CLEVE HILL SOLAR PARK

STATEMENT OF COMMON GROUND BETWEEN THE APPLICANT AND LOWER MEDWAY INTERNAL DRAINAGE BOARD

August 2019
Revision A

Document Reference: 12.2.5
Submitted: Deadline 4

Produced By: LN	Ref: 2238-PUB-085
Checked By: MB	Date: 23/06/2019

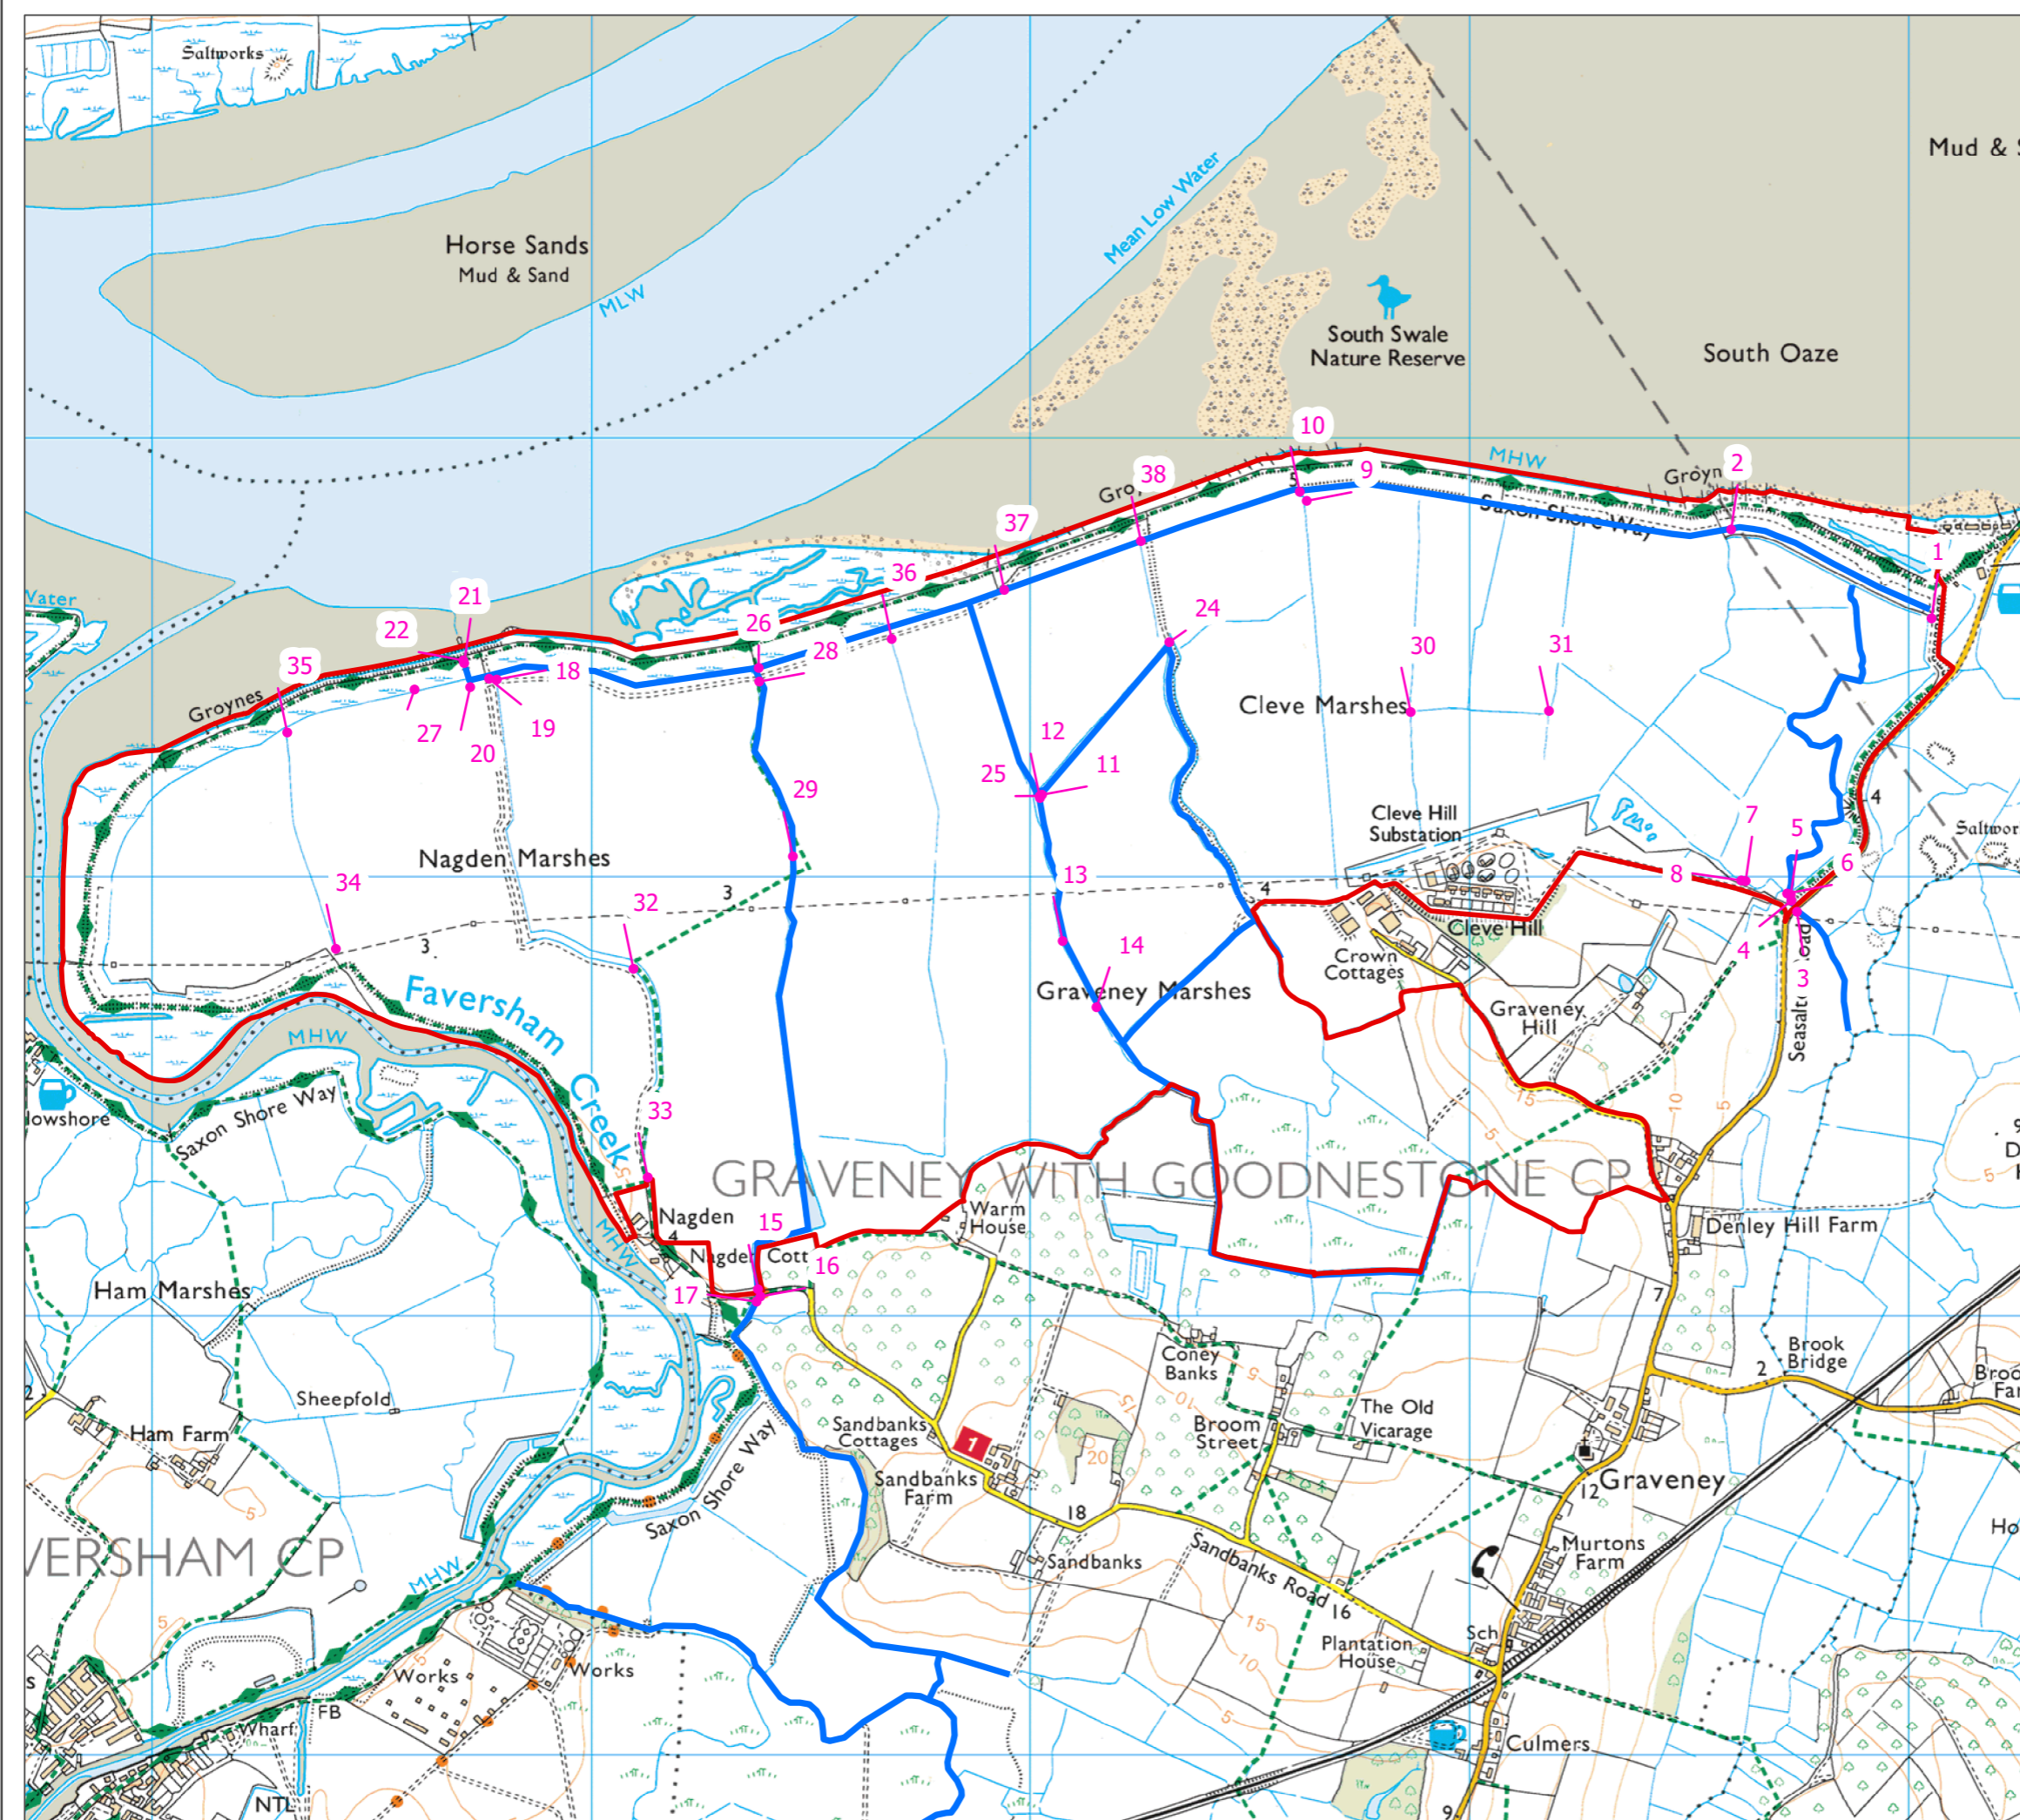
Rule 6 Letter SoCG Request	Applicant's Response	Status (LM IDB to complete)
	<p>262830).</p> <p>Photographs 3 and 4 on Figure 2238-PUB-085 in Appendix A of this SoCG show that existing flow control structures such as sluice gates can isolate the Development area from flows originating in Back Stream watercourse to the southeast of the Site (east of Seasalter Road).</p> <p>Similarly, existing outfalls and flow control structures are operated by Lower Medway IDB on Thorn Creek (LM IDB asset ID 58) to the south west of the Development (in proximity to Thorn Sluice Outfall – operated by the EA² Asset ID: 257358), which can be managed to ensure water levels within the Development can be isolated from levels in the immediate and wider catchment outside the Application site boundary.</p> <p>As such, raising water levels onsite via the existing flow control infrastructure and via non-return valves or sluice gates will not lead to an unacceptable change to the hydrological regime offsite.</p> <p>It is proposed that a detailed method statement will be submitted to the IDB and the HMSG for approval prior to the works being undertaken, as part of a Land Drainage Consent Application.</p> <p>Any initial works to construct infrastructure to alter water levels within watercourses, such as the installation of drop boards sluices, will require Land Drainage Consent from the LM IDB. This consent will be applied for alongside the discharge of Requirements 2 (h) 8 and 10 of the dDCO.</p> <p>The Applicant seeks agreement from the LM IDB that the proposed water level management and arrangements for works within watercourses as set out above will not have an adverse effect on offsite hydrology and water management and are therefore acceptable.</p> <p>Drains and control structures (such as outfalls) are labelled on Figure</p>

Produced By: LN	Ref: 2238-PUB-088
Checked By: MB	Date: 23/06/2019

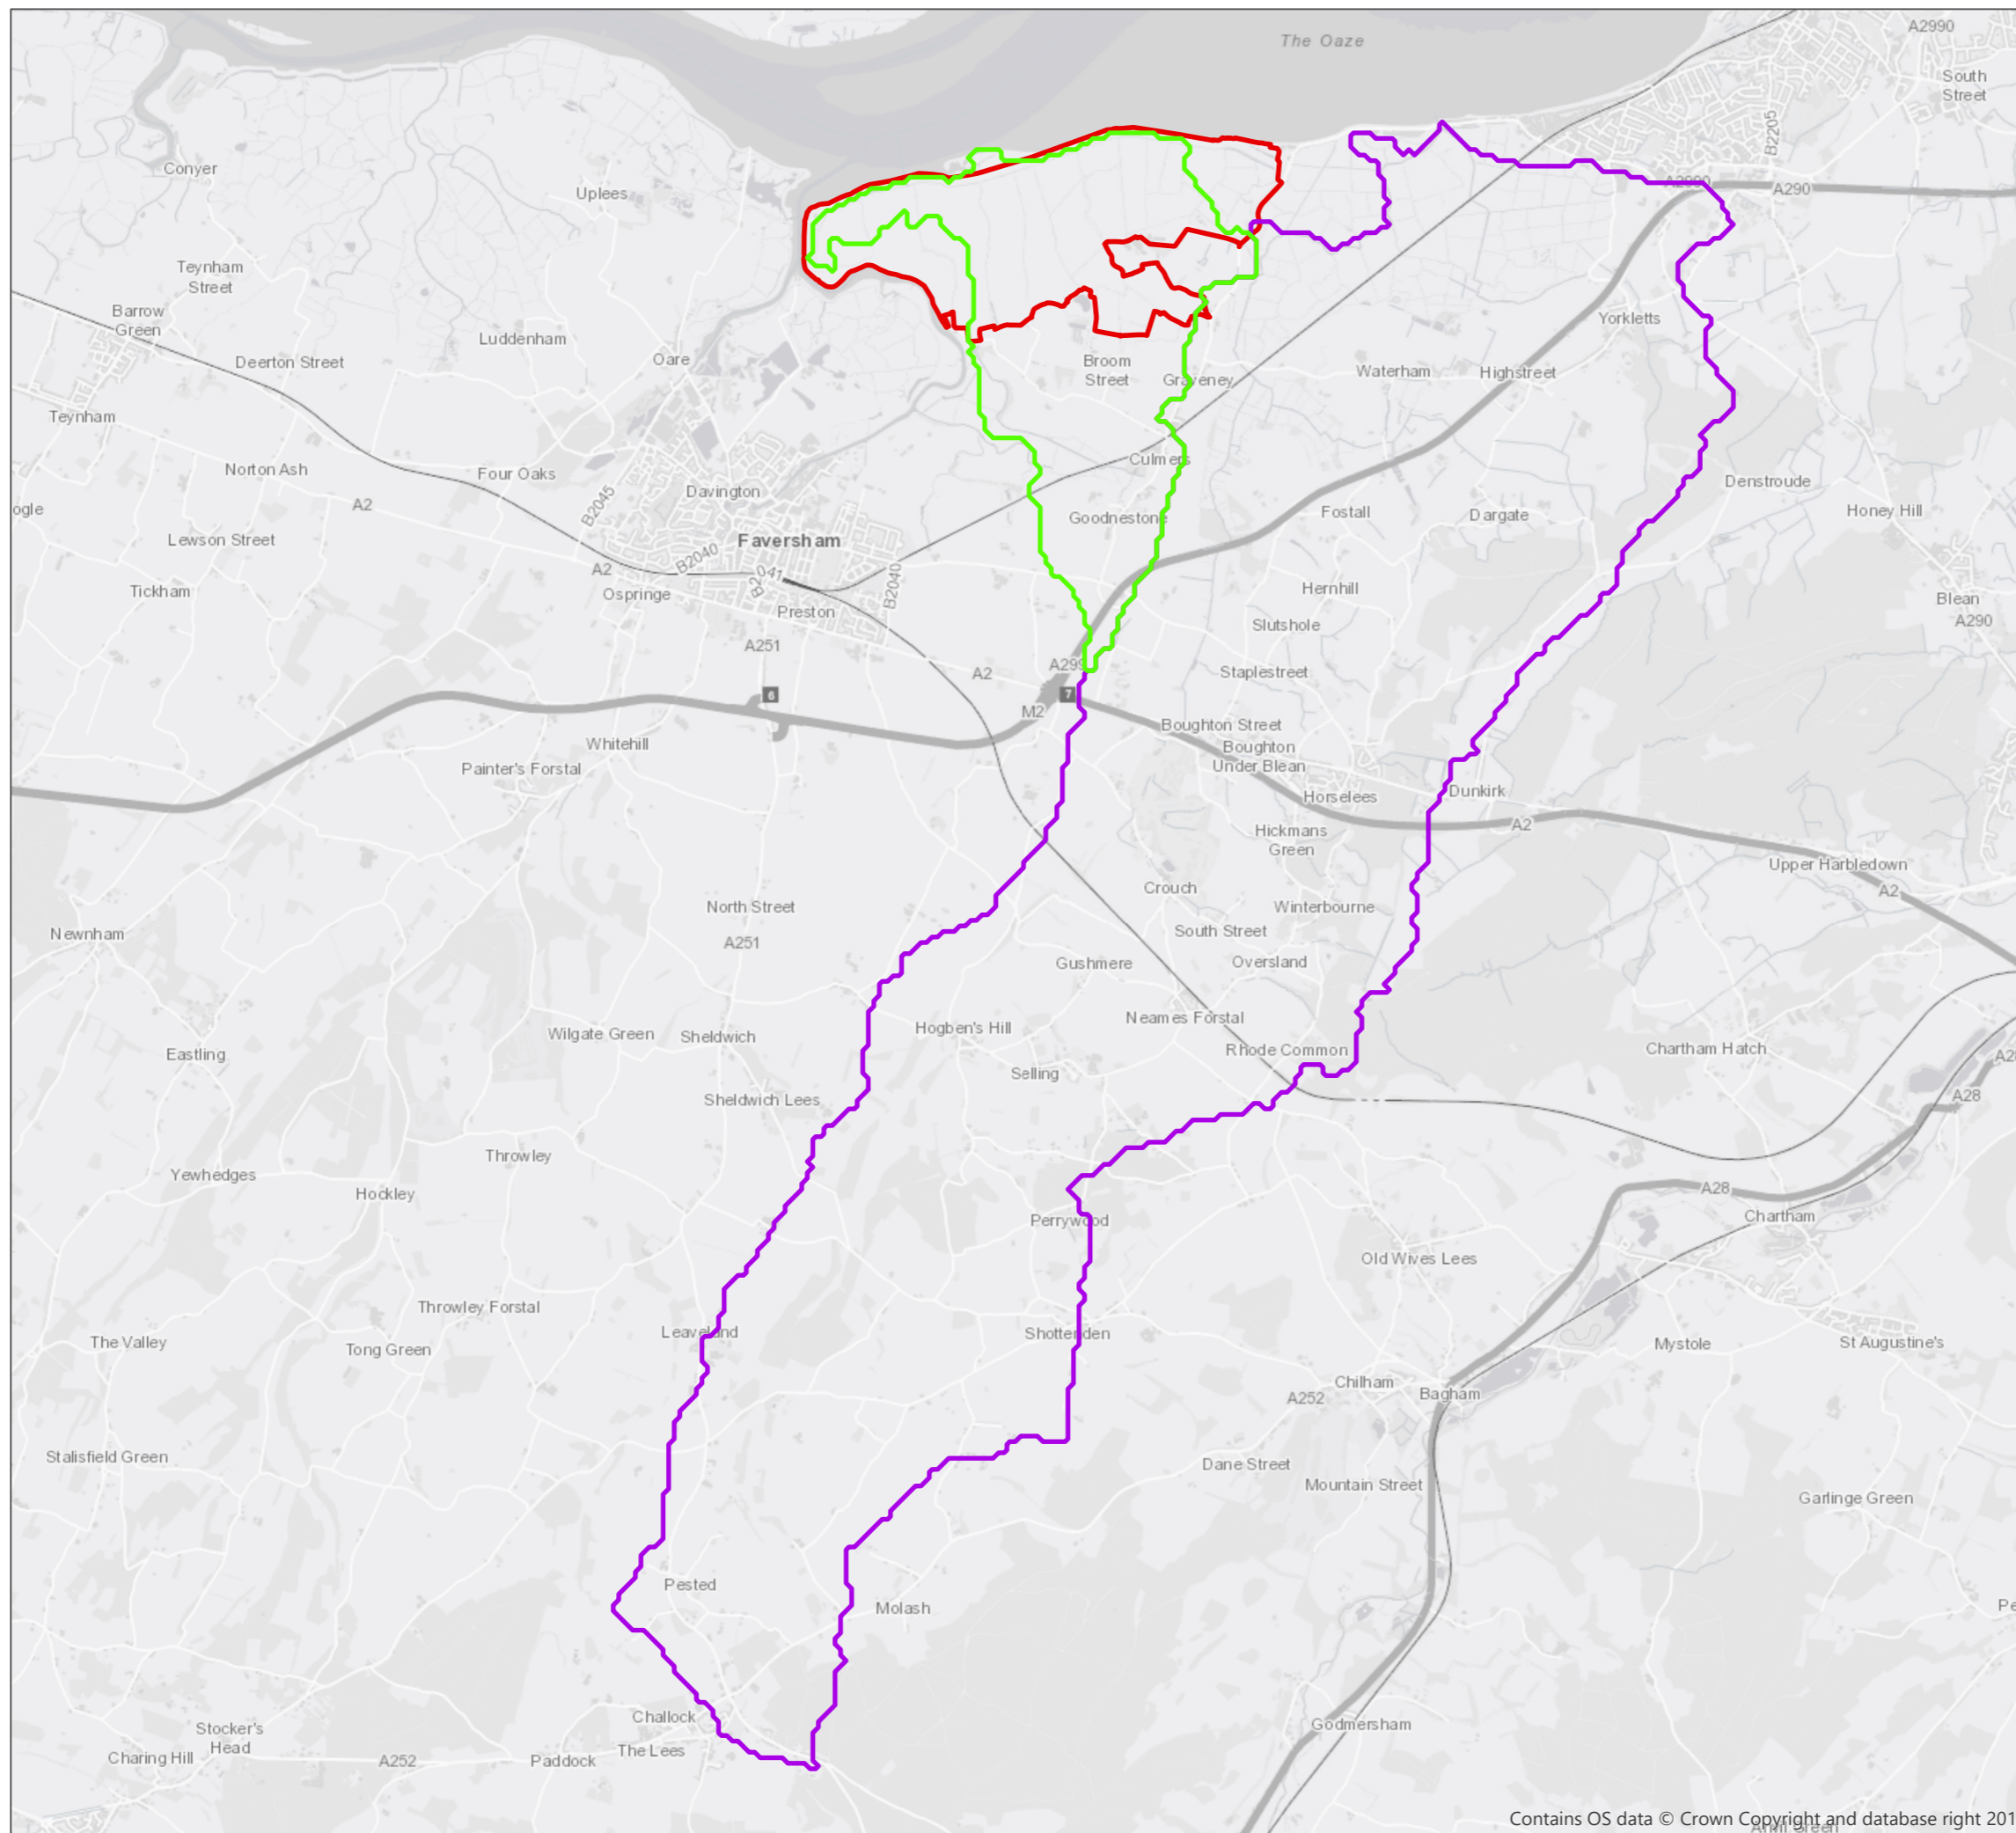
<p><u>Offsite Hydrological Impacts</u> Figure 2238-PUB-086 in Appendix A of this SoCG shows a catchment plan derived from Flood Estimation Handbook data, indicating that the Site is drained by a network of drainage ditches that do not have a wide catchment outside the control of the Applicant. The Development drains a catchment of 776 ha and offsite watercourses enter site through Nagden Drain (LM IDB asset ID 55), Graveney Church Drain (LM IDB asset ID 57), Cleve Cottage Drain (LM IDB asset ID 56) and White Drain (LM IDB asset ID 46A). These in turn discharge from the Development site via Nagden Sluice (EA Asset ID: 265437). Back Stream (LM IDB asset ID 48) flows from southwest to northeast before discharging into The Swale, approximately 2 km northeast of the Development, via Seasalter Pumping Station (EA Asset ID:</p>
